Staff Report

To: Development Review Board
From: Michael Giguere, City Planner
Meeting Date: April 17th, 2025
Subject: Final plat review for a three-lot subdivision for one residential lot and two lots for future development; road connection of Taft Street to Meadow Terrace in the R1 District by Center for Technology Essex, owners.
File: SP# 7.2024.1 and SP# 7.2024.2

Three-lot subdivision and boundary line adjustment of the 6.11-acre lot located at the end of Taft Street and road connection of Taft Street to Meadow Terrace for the continuation of the Residential Building Trades program at the Center for Technology, Essex (CTE). The new road connection is proposed to be named "Meadow Terrace" to meet Vermont state addressing standards. Proposed new lot 6A will be the location of the next home, and lots 7A and 8A will remain undeveloped until plans for future subdivision are finalized.

C-1.1

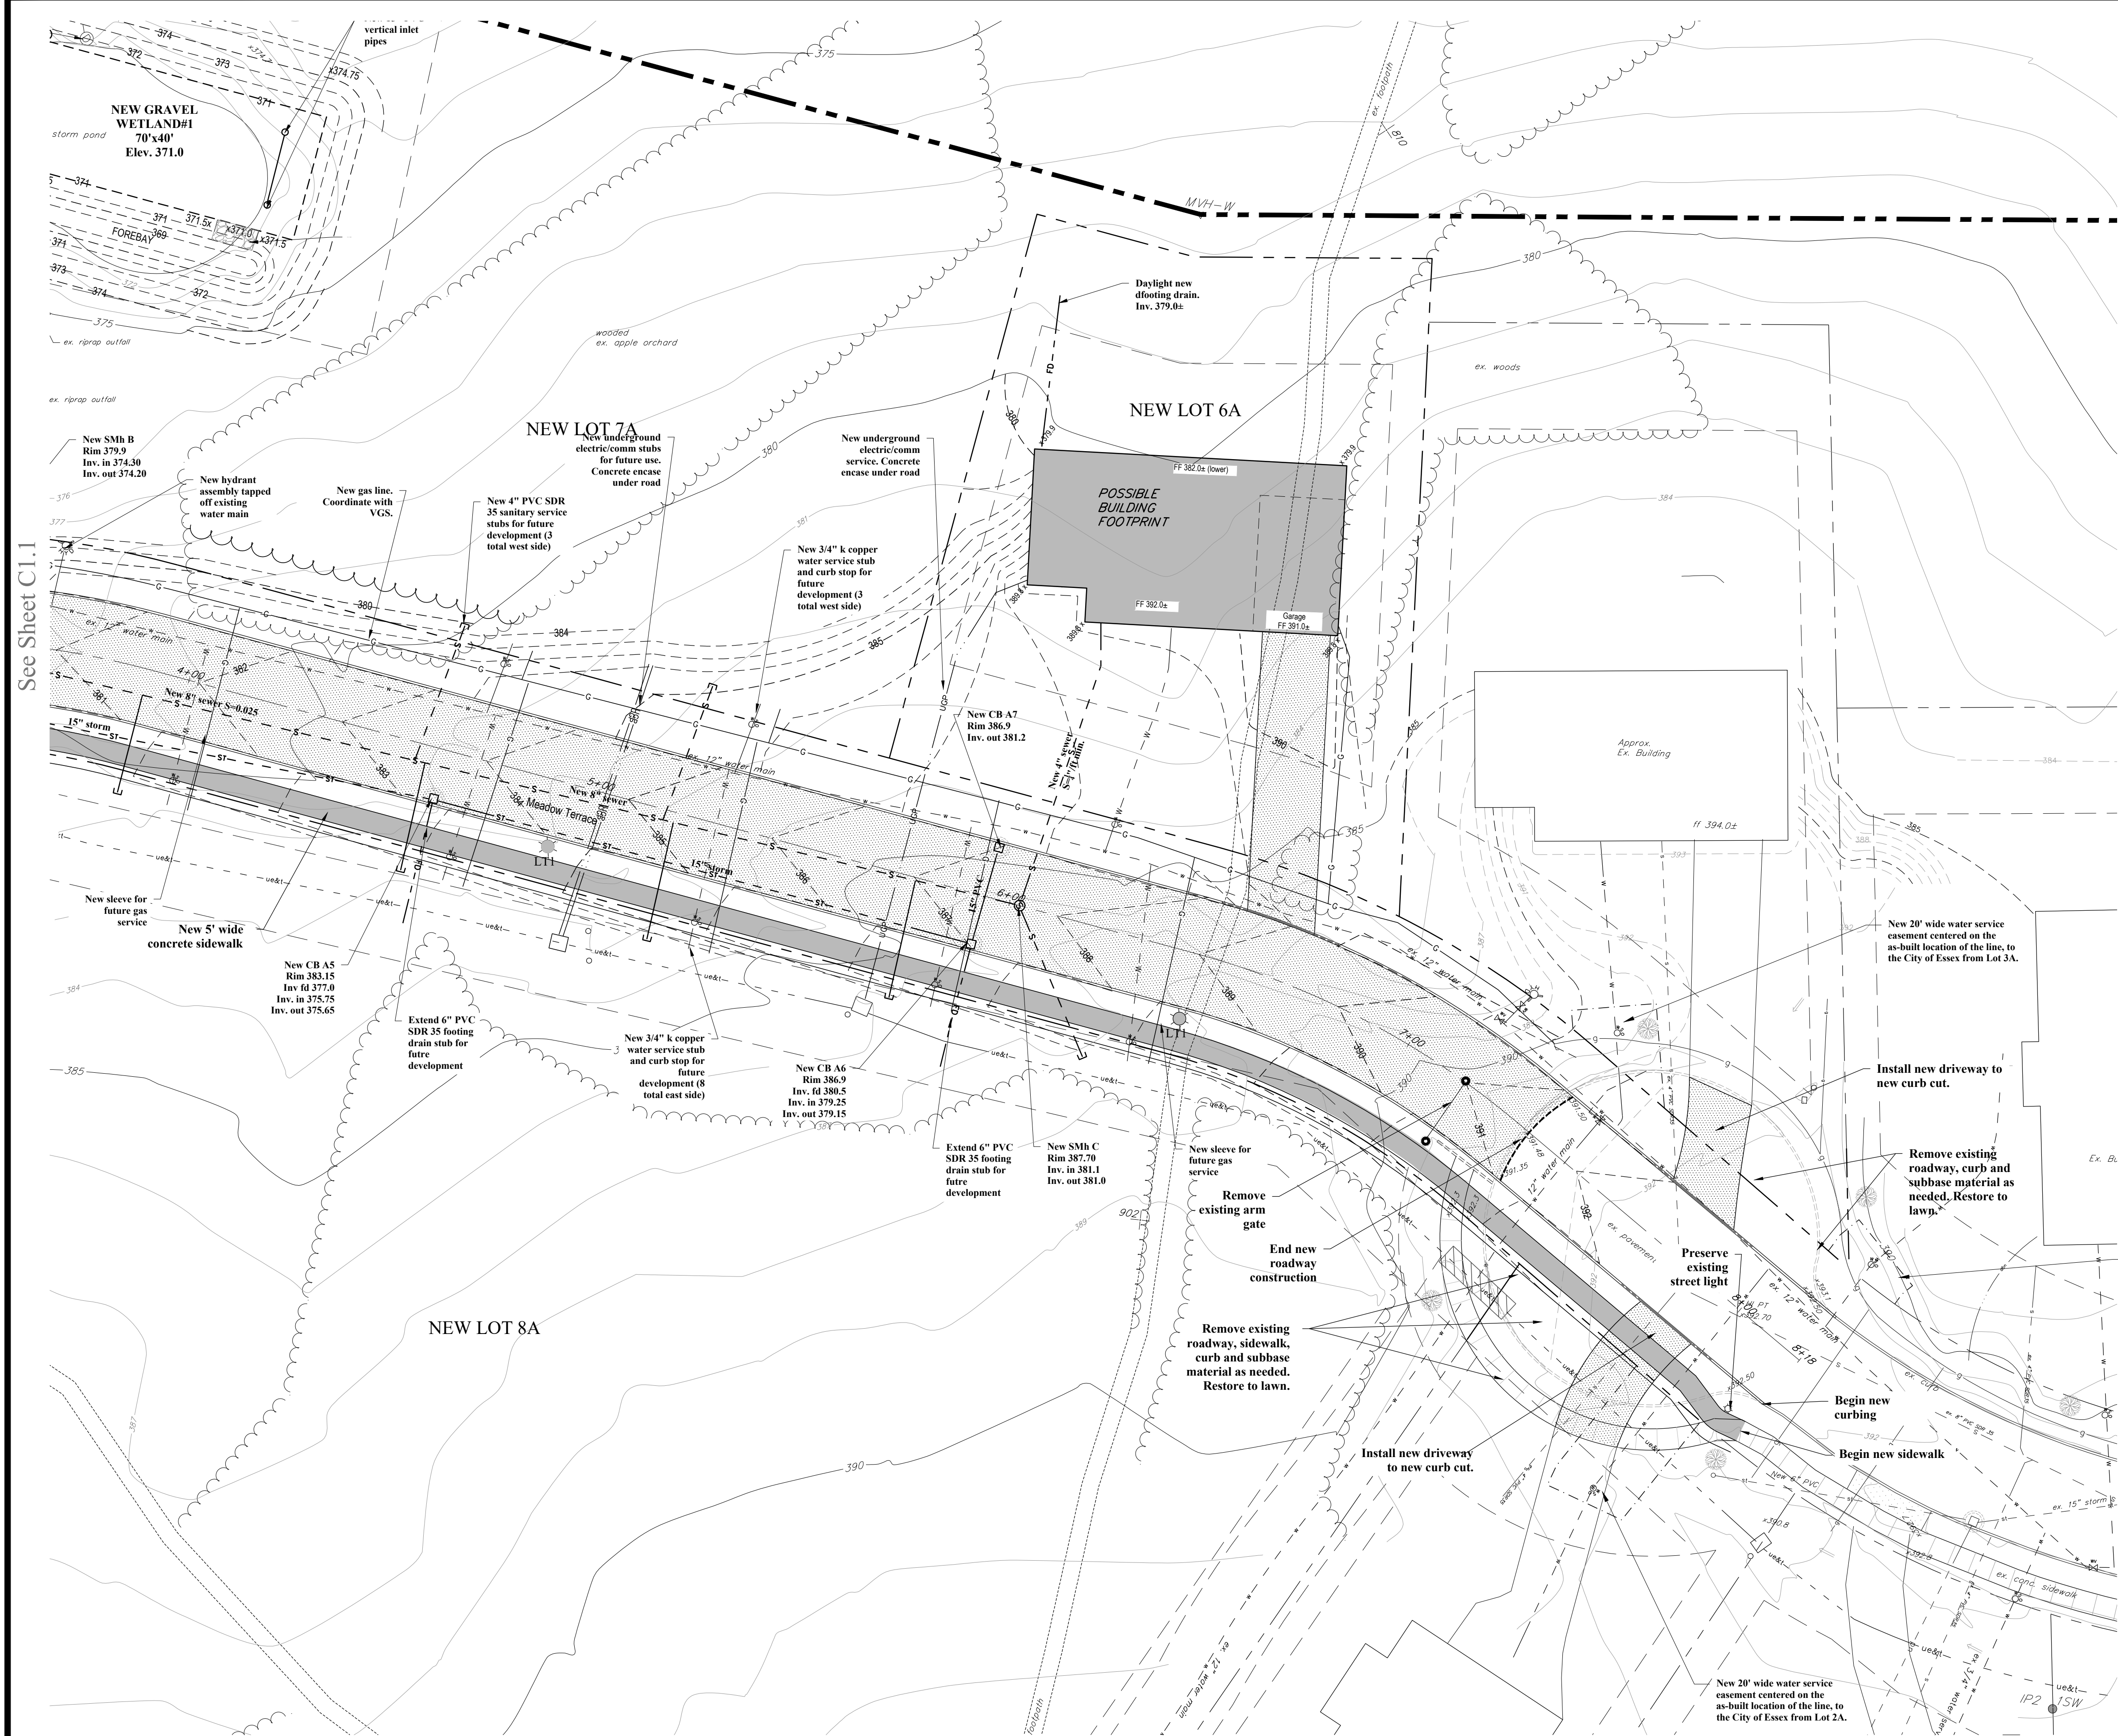
- 3) On Sheet C-1.1, a note should be added requiring an authorized representative of the City of Essex Junction to inspect all pipelines (water, sewer, and storm drainage) prior to backfill. This note should require a minimum of 48 hours advance notification of the need for inspection.

- 3) On Sheet C-1.2, the new sidewalk jogs at approximately station 8+10 to avoid an existing light pole where it ties into the existing sidewalk. In doing so, the new sidewalk extends partially outside of the City right-of-way. The plans should be revised such that the new sidewalk remains entirely inside the City right-of-way.

- 1) On Sheet C-1.1, note #8 states that “*All new storm pipes shall be PVC SDR 35 unless otherwise noted.*” On Sheet C-3.0, the profile labels all of the new stormwater pipes as being “*new 15” HDPE*”. In addition, On Sheet CD-1, General Construction Note #20 states “*All sewer and storm pipes shall be PVC SDR 35 unless otherwise noted.*” The plans should be revised to resolve this conflicting information and specify the size and material for new stormwater piping.

The Owner is willing to install the future service for 5 Meadow Terrace. This line has been added to Sheet C1.1.

CD-1

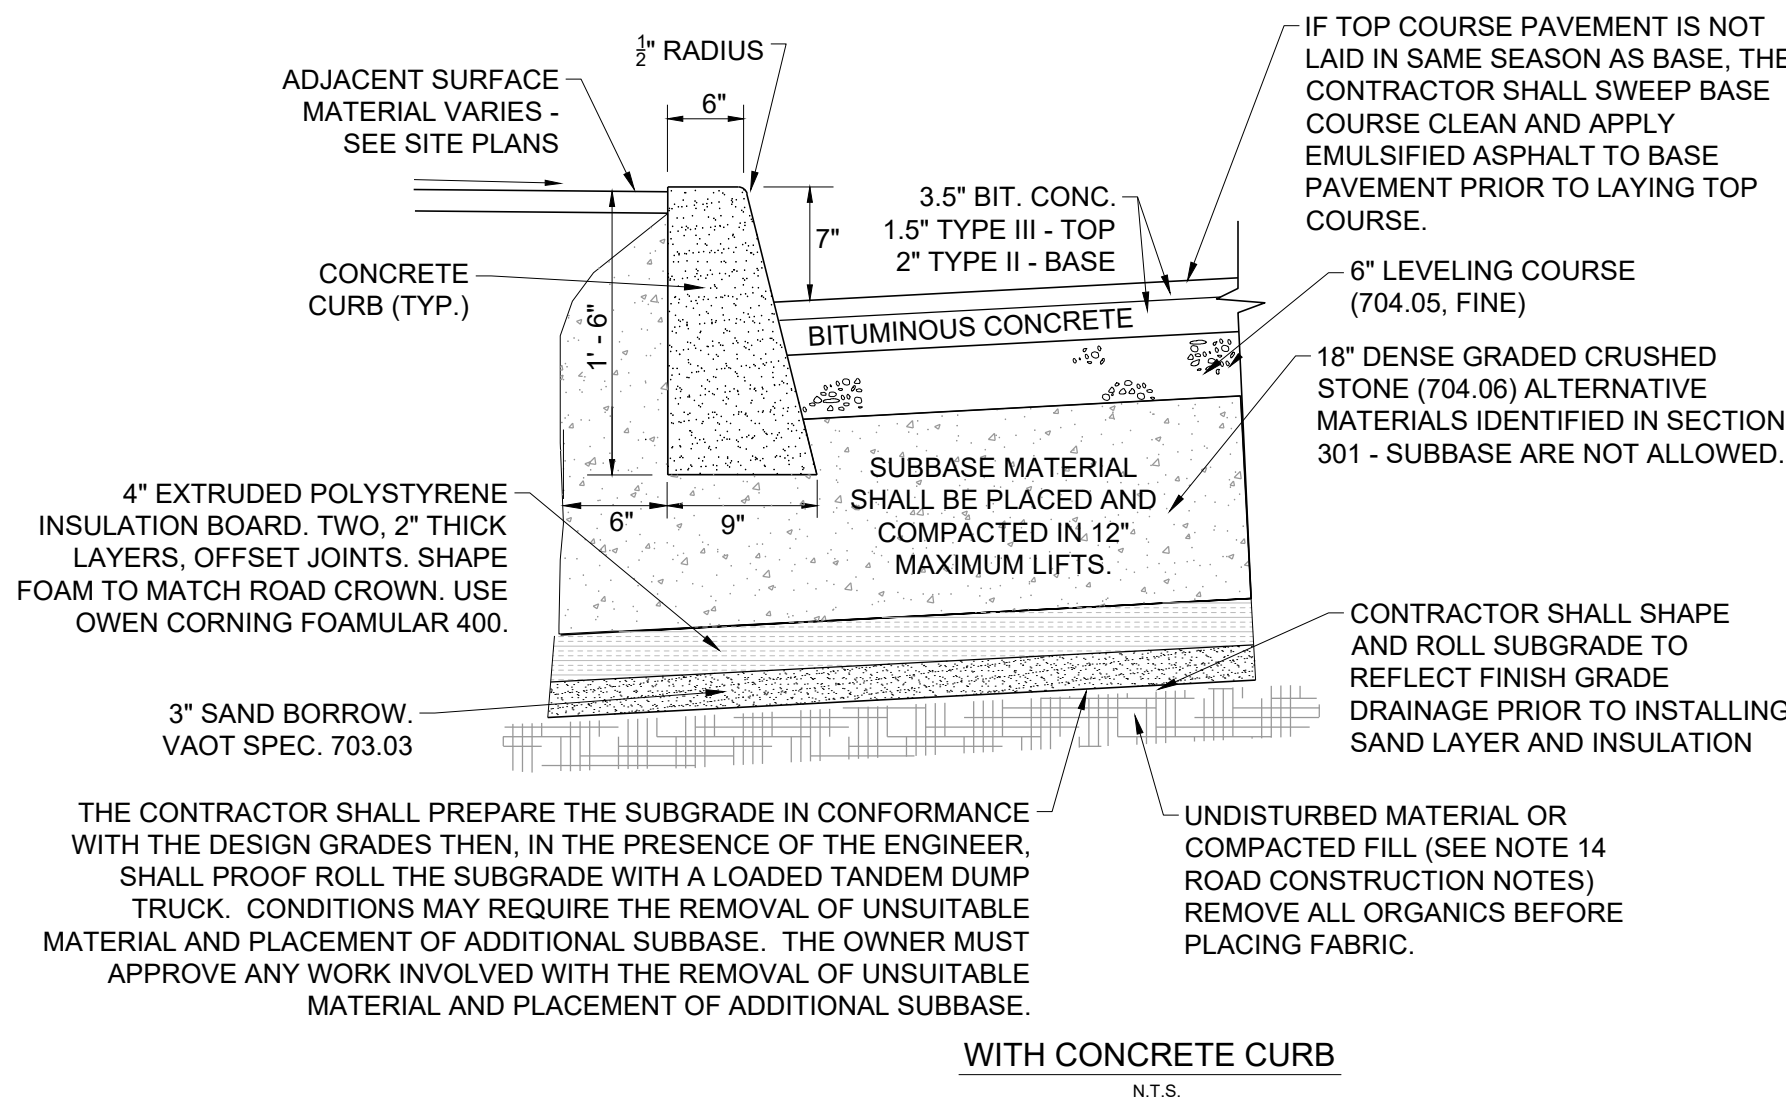
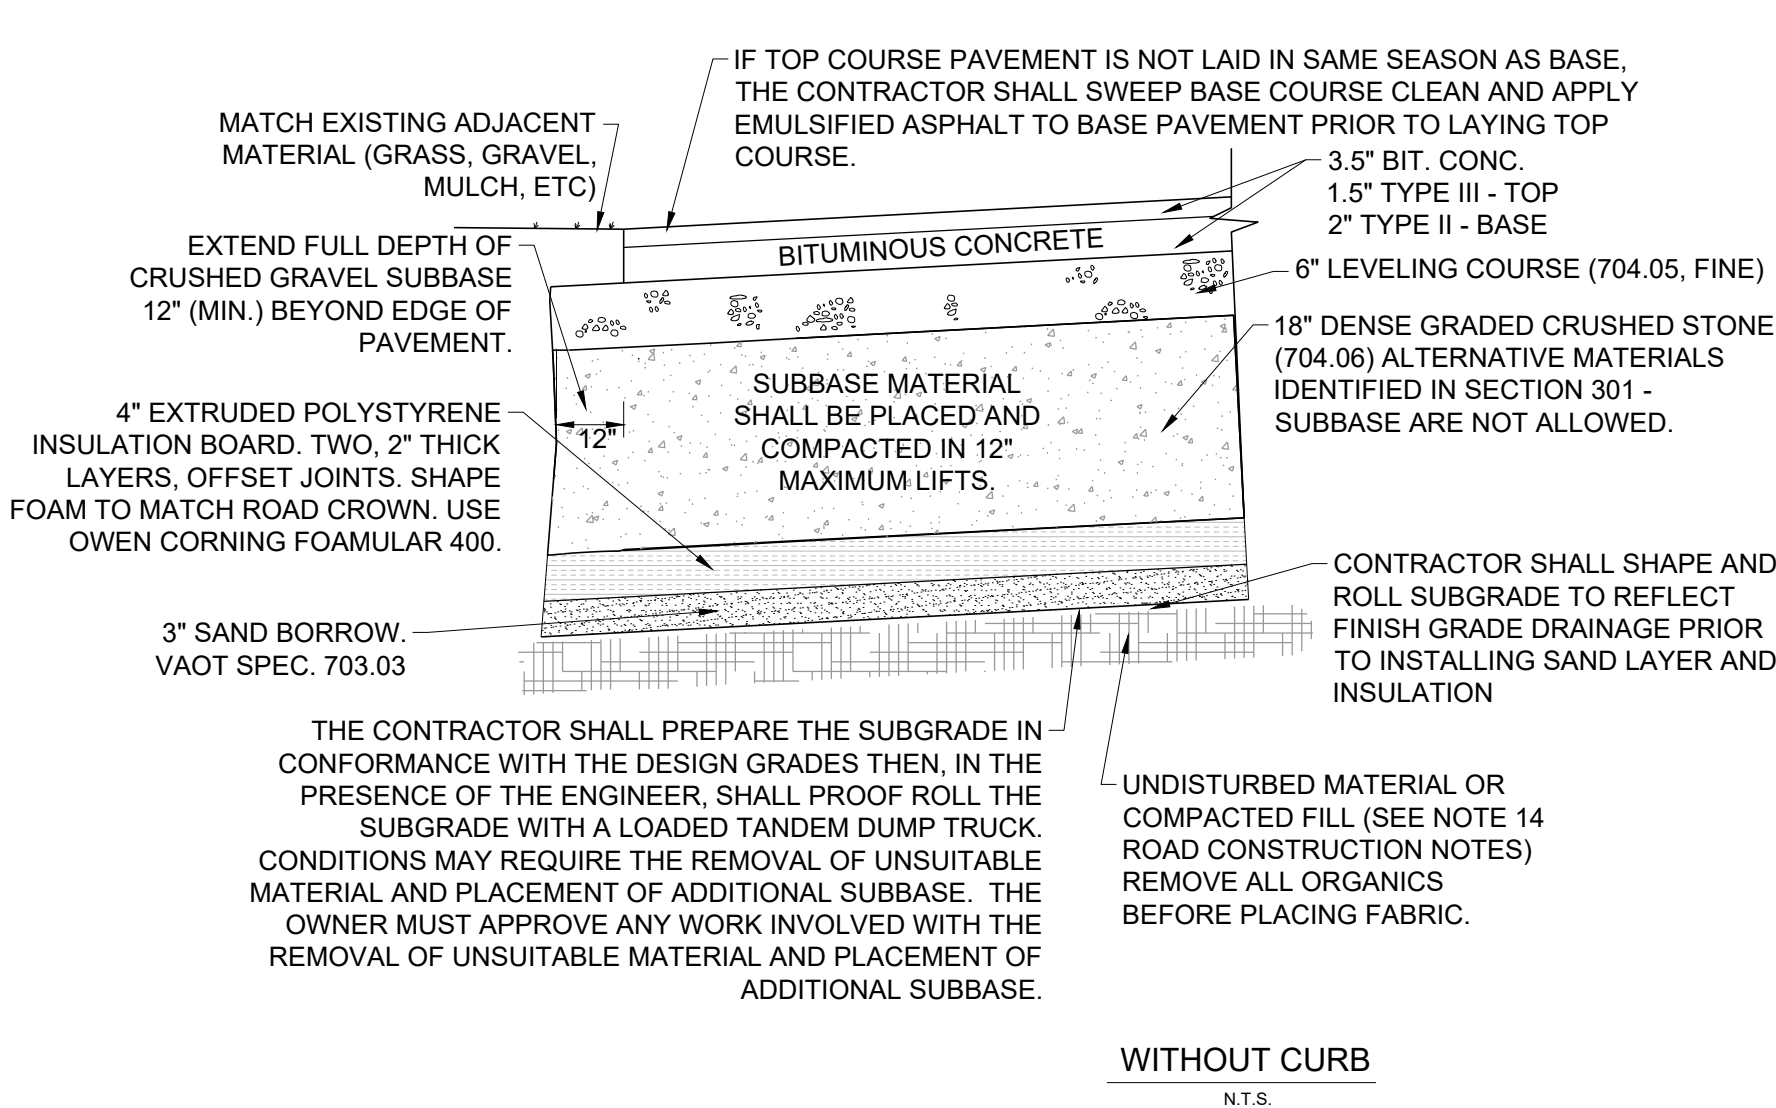
- 4) On Sheets CD-1, CD-3, CD-4, and CD-5, there is a note stating “*All sewer, water, and storm drainage utilities installed on the project SIDE **[emphasis added]** to be observed by an authorized representative of the City of Essex Junction prior to backfilling the utility being installed.*” This note should be revised to state “*...on the project site...*”.
